dish wireless™

# DNDEN00092B

# 1444 SOUTH POTOMAC STREET
# AURORA, CO 80012

**City of Aurora Building Division**
**Reviewed for Code Compliance**
**Approved as Noted:** *Bobby McKinzie*
**Date:** *Jun 01, 2021*
**2015 INTERNATIONAL CODES & 2020 NEC**

H-FRAME DETAIL | NO SCALE | 3

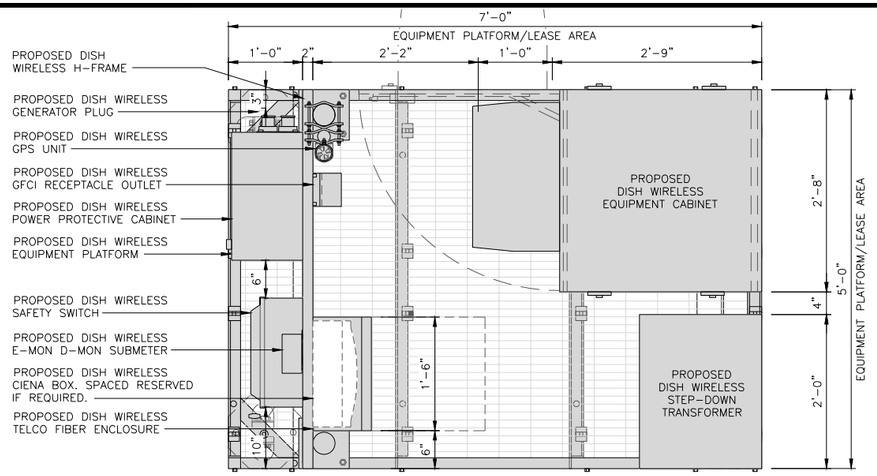
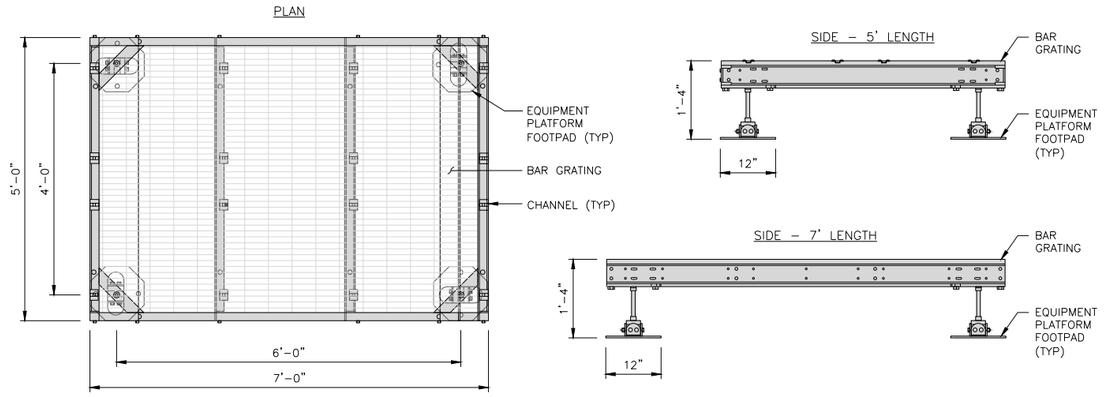
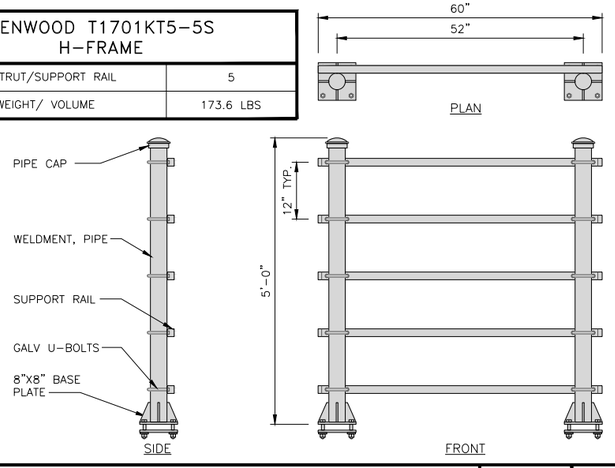
Structural plan review is limited to a general survey for code compliance. No review is implied nor was undertaken to verify structural adequacy.

ELECTRICAL/FIBER ROUTE PLAN AND NOTES

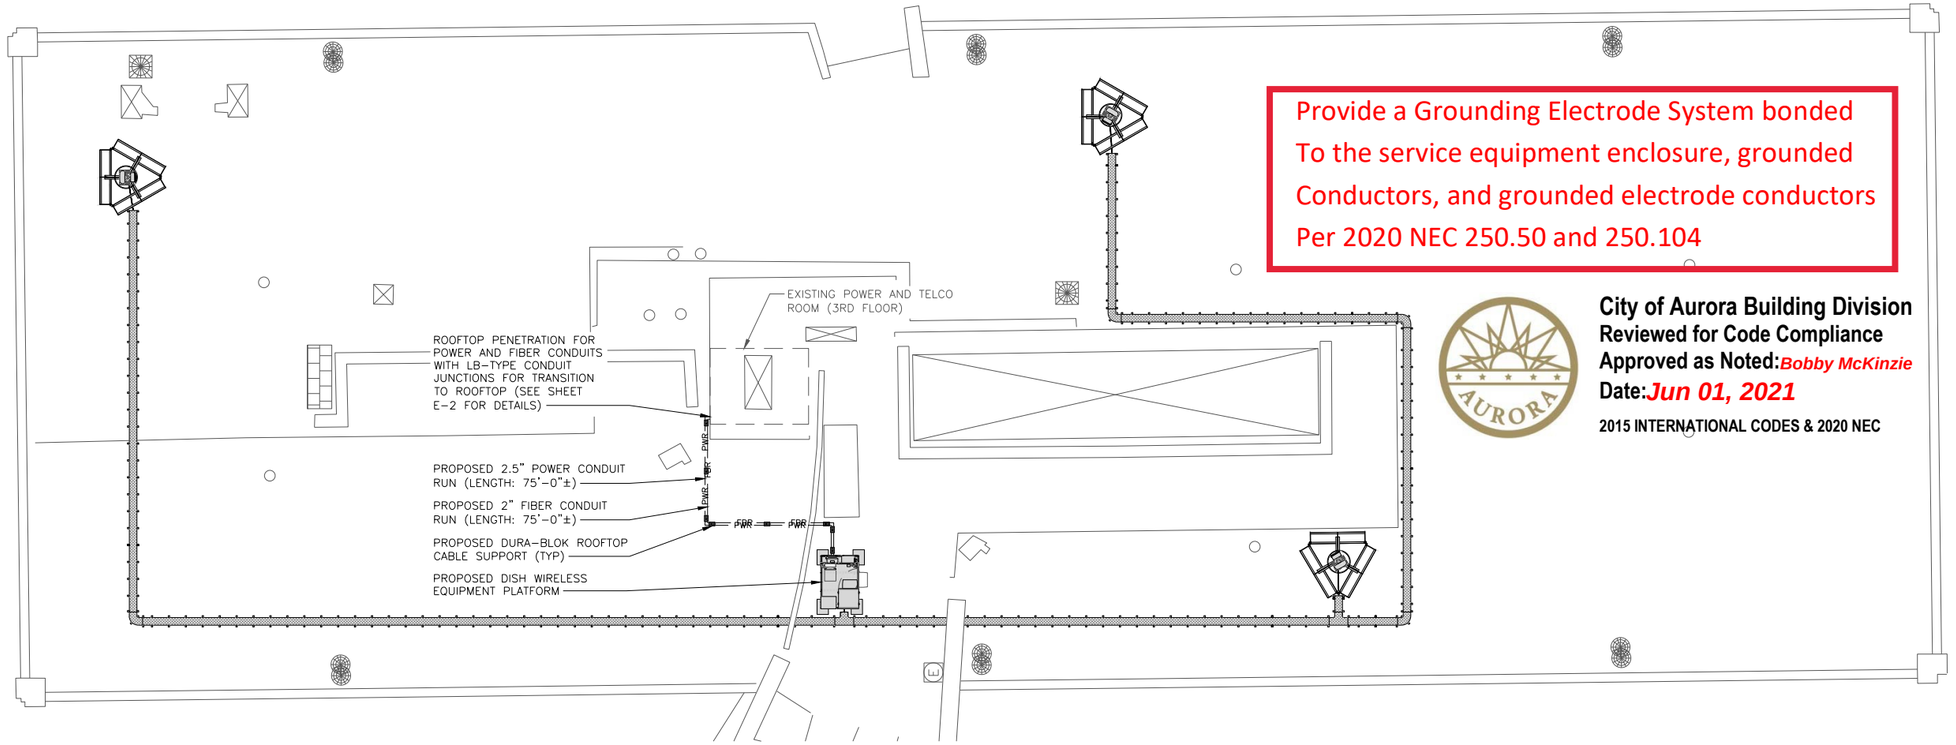
Provide a Grounding Electrode System bonded
To the service equipment enclosure, grounded
Conductors, and grounded electrode conductors
Per 2020 NEC 250.50 and 250.104

SHEET TITLE
ELECTRICAL DETAILS

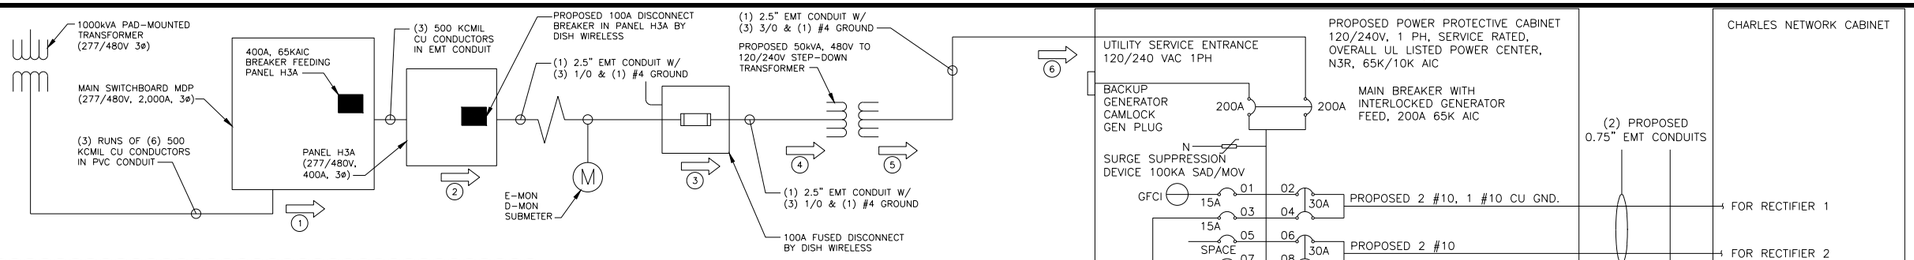
Install electrical connections per 2020 NEC 110.14, Identify disconnects per 2020 NEC 110.22 and provide working space around Electrical equipment per 2020 NEC 110.26

SHEET TITLE
ELECTRICAL ONE-LINE, FAULT CALCS & PANEL SCHEDULE

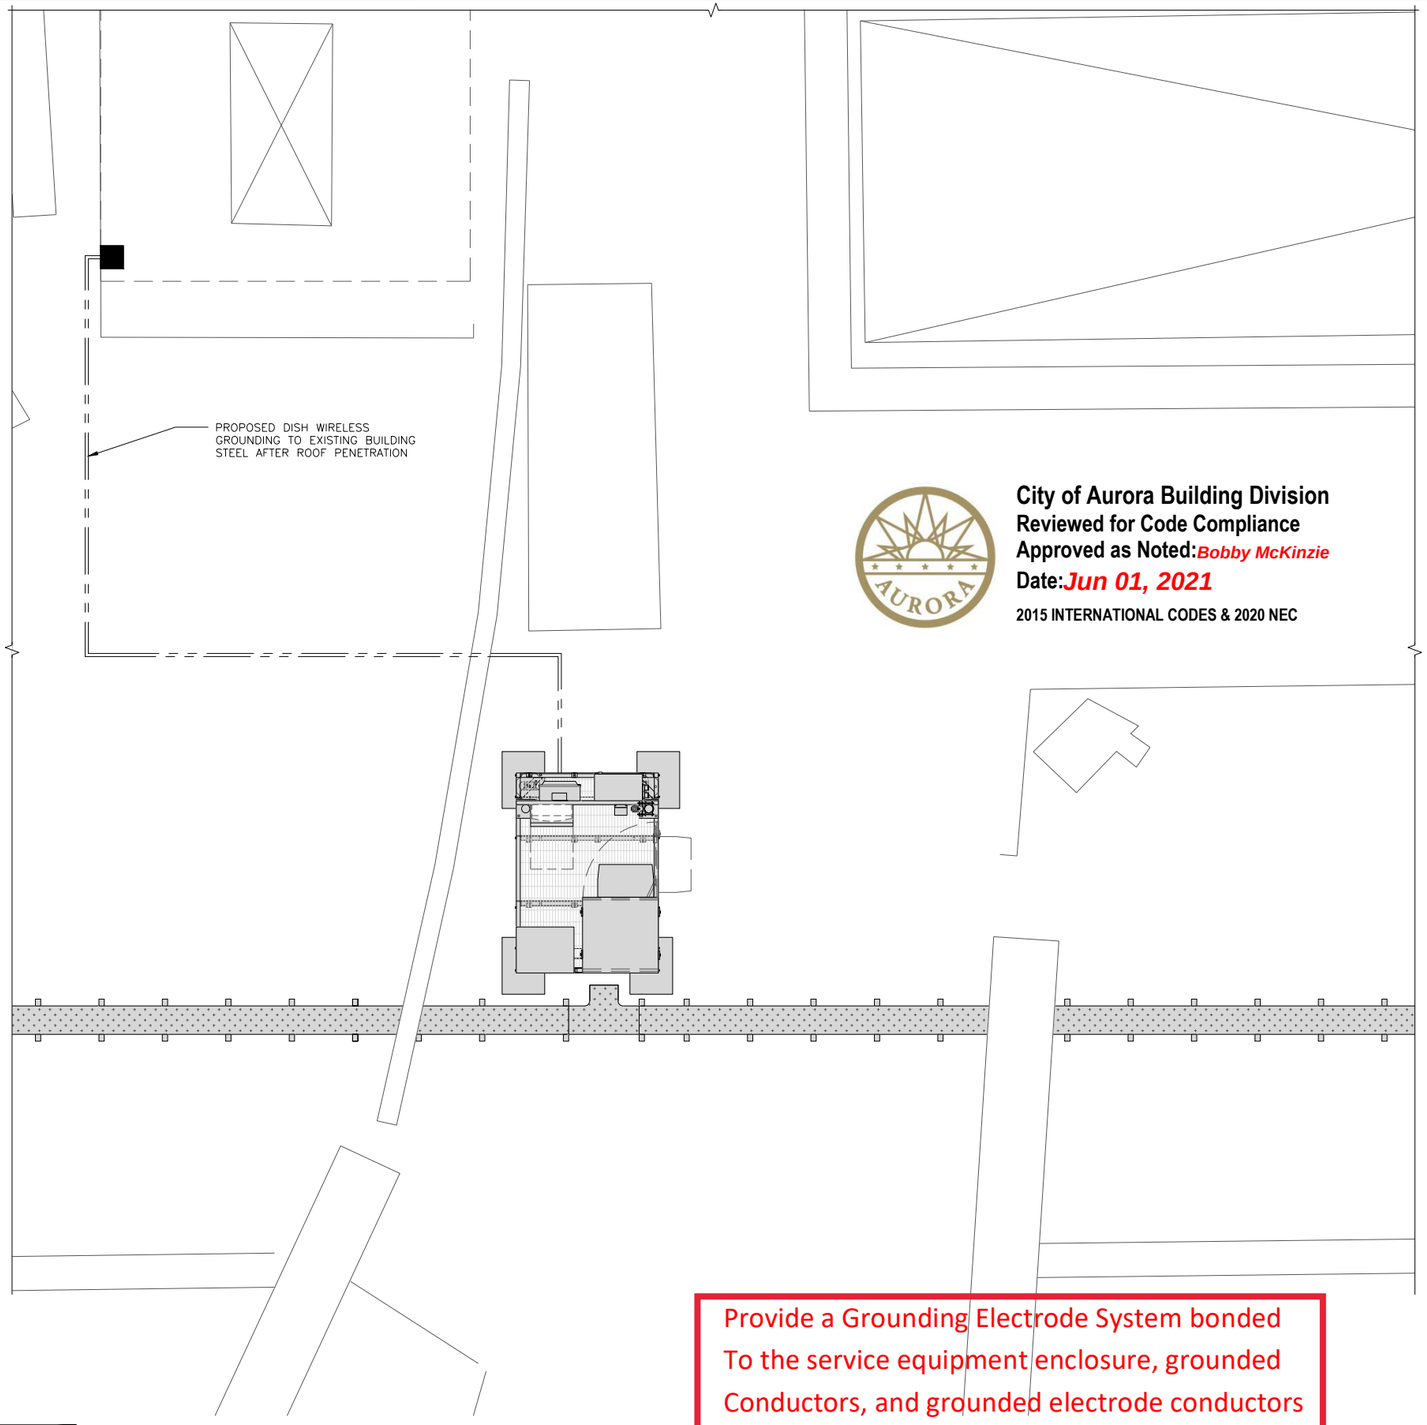
*CONTRACTOR WILL PROVIDE PERMANENTLY ENGRAVED PLAQUE AT THE SUB-METER/DISCONNECT THAT LISTS THE AVAILABLE FAULT CURRENT AND DATE OF CALCULATION (05/28/21)

Install electrical connections per 2020 NEC 110.14, Identify disconnects per 2020 NEC 110.22 and provide working space around Electrical equipment per 2020 NEC 110.26

Every circuit and circuit modification shall be legibly Identified as to it's clear, evident and specific purpose or use. The identification shall include an approved degree of detail that allows each circuit to be distinguished from all others. 2020 NEC 408.4

SHEET TITLE
GROUNDING PLANS AND NOTES

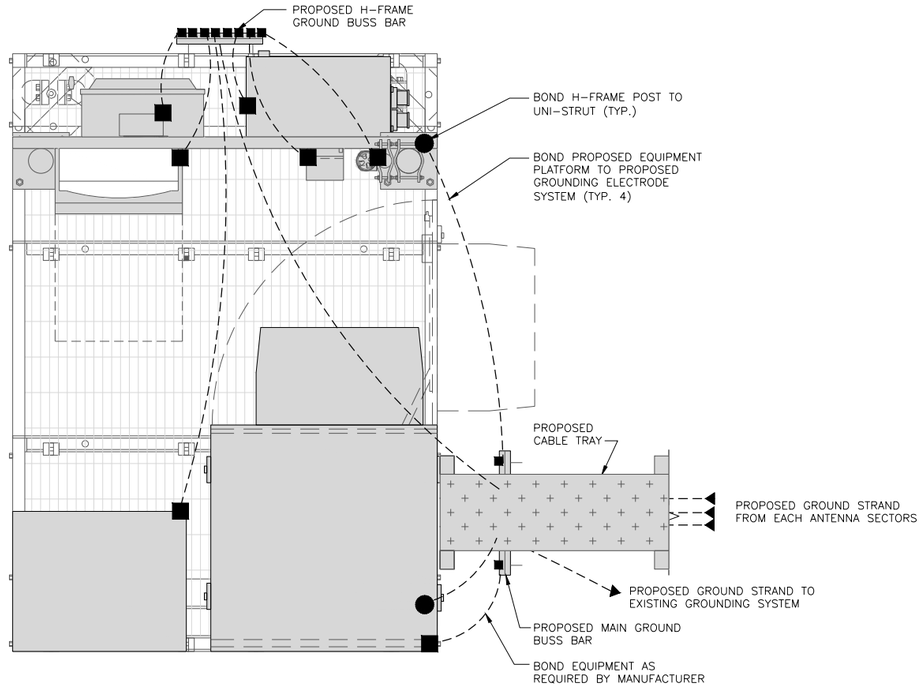
Provide a Grounding Electrode System bonded
To the service equipment enclosure, grounded
Conductors, and grounded electrode conductors
Per 2020 NEC 250.50 and 250.104

SHEET TITLE
GROUNDING DETAILS

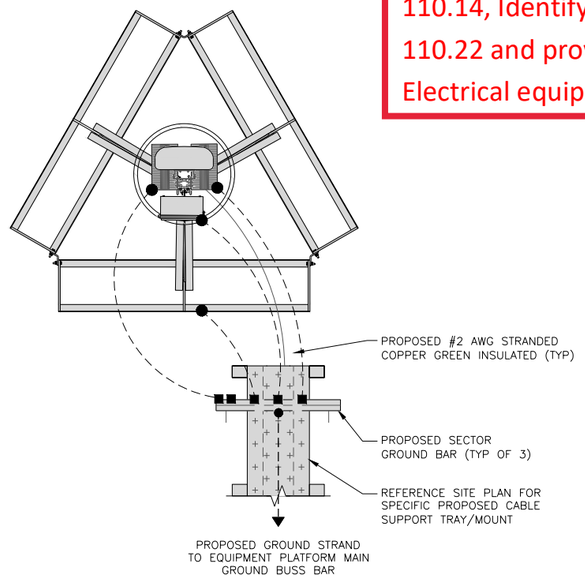
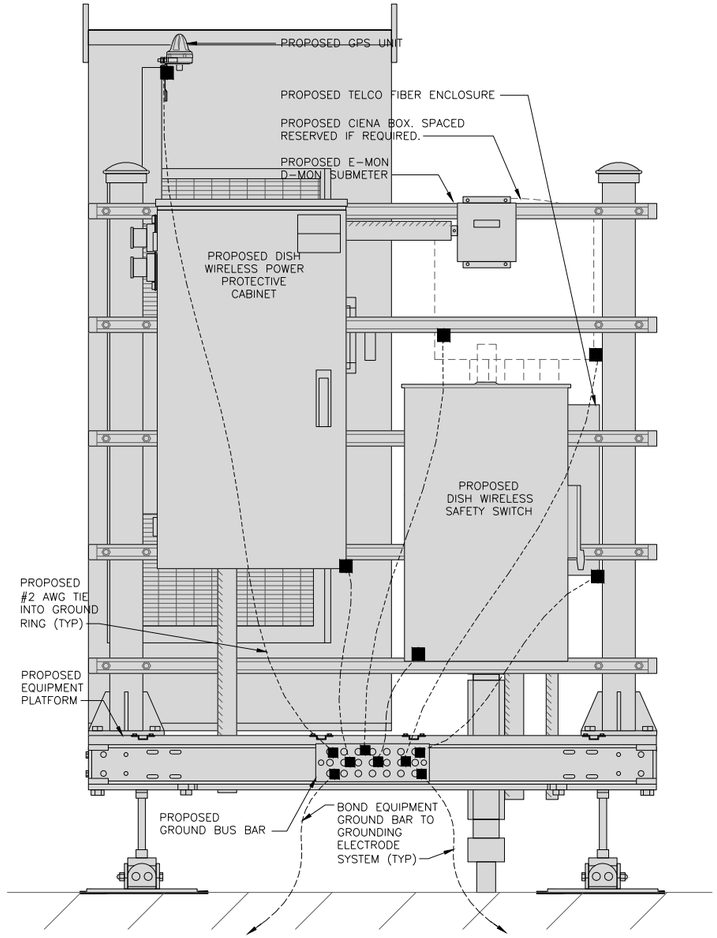
Install electrical connections per 2020 NEC 110.14, Identify disconnects per 2020 NEC 110.22 and provide working space around Electrical equipment per 2020 NEC 110.26

Provide a Grounding Electrode System bonded To the service equipment enclosure, grounded Conductors, and grounded electrode conductors Per 2020 NEC 250.50 and 250.104
